## **NDE reliability issues**

### ***Industry perspective and action plan***

NRC Public Meeting      May 30, 2012      White Flint

# Response to NRC Concerns

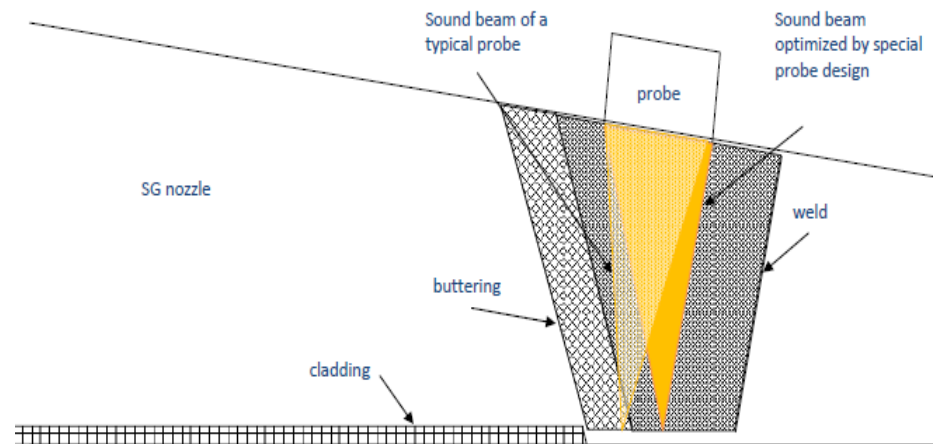
- *The second issue is possible variable quality probes. Neither the qualification process, nor the site specific mock up have provisions for acceptance testing or evaluation of purchased probes. Additionally, the probes were designed to be used in one scanning direction only, but a lack of prominent warnings or ergonomic indicators provided an error trap for inspectors who might not recognize that they are applying the probe contrary to the intent of probe design.*

- Industry Response to Concern 2
  - Current industry procedures require that the search unit angle be within 3° of what is specified
  - The ability to detect and correctly position the flaws within the site specific mock-up is a additional verification that the search units are within the design parameters
  - The documentation provided by the manufacturer clearly denotes which scan direction the search units were designed for
  - Actions
    - Additional guidance for verifying critical parameters during the receipt inspection and calibration of complex search units
    - Industry guidance documents will be revised to include recommended practices with regards to use of complex search units including the use of indicators to potentially reduce human error
